## Changeover of the brake camshaft to the K3 generation for the drum brake

### K3 generation brake camshaft

#### Fastening type K3 generation

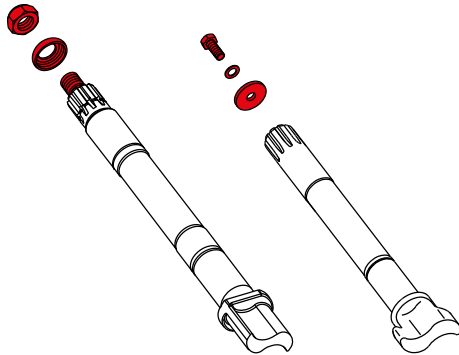
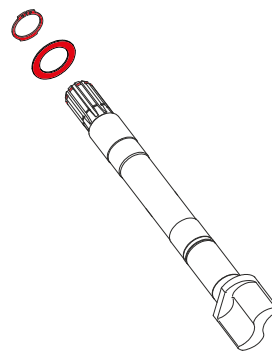
The changeover of the brake camshaft to the K3 generation involves changing the fastening of the automatic slack adjuster and will take place in the first step for the drum brake with the brake sizes 300x100 and 300x200.

For the K2 generation, there are two types of fastening for the automatic slack adjuster and this will be changed over to a fastening type that prevents slipping of the automatic slack adjuster off of the spline shaft.

Bolted K2 version with locknut/bolt and washer

K3 version with circlip and washer

**None**, since use of the K3 brake camshaft can be used backward compatible for the K2 generation.

In cases where spare parts are required (for your brake size after the changeover), you will automatically receive the K3 generation if you have ordered the K2 generation. Mixed installation on one axle is allowed.
